From: [REDACTED]
To: [REDACTED]
CC: [REDACTED]
Sent: 3/3/2021 8:53:46 AM
Subject: RE: O8W-PM 35217268, 35224712, 35224713 - Bucks Creek 1101 Phase 1,2&3 - Pre-Engineering Meeting

Subject: O8W-PM 35217268, 35224712, 35224713 - Bucks Creek 1101 Phase 1,2&3 - Pre-Engineering Meeting

Bucks Creek 1101- PM# 35217268 Overview Map

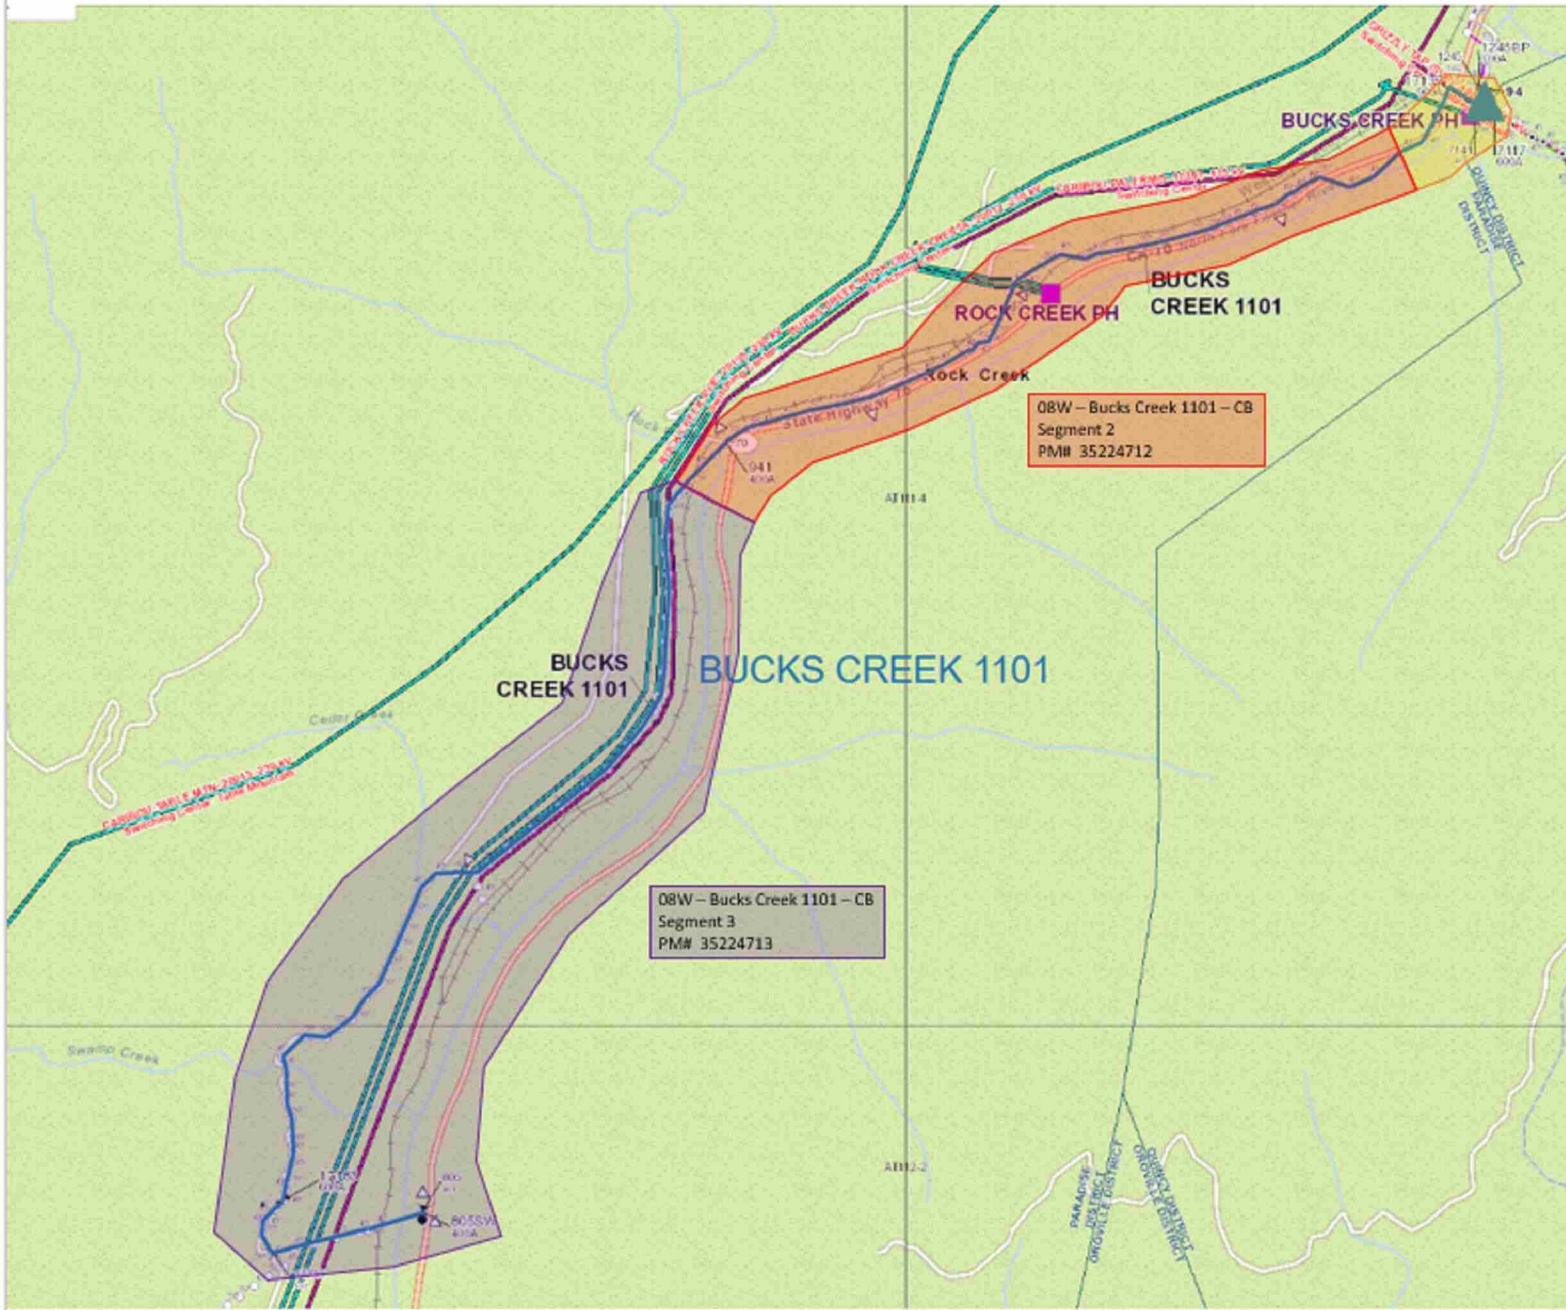
For Bucks Creek there is quite a bit of work surrounding Hwy 70 and we will need a Land Department Base Maps prepared for all 3 Orders. This will delay the EOD dates until these can be developed and provided to the Vendor... We will also need answers to the questions outlined by [REDACTED] below...
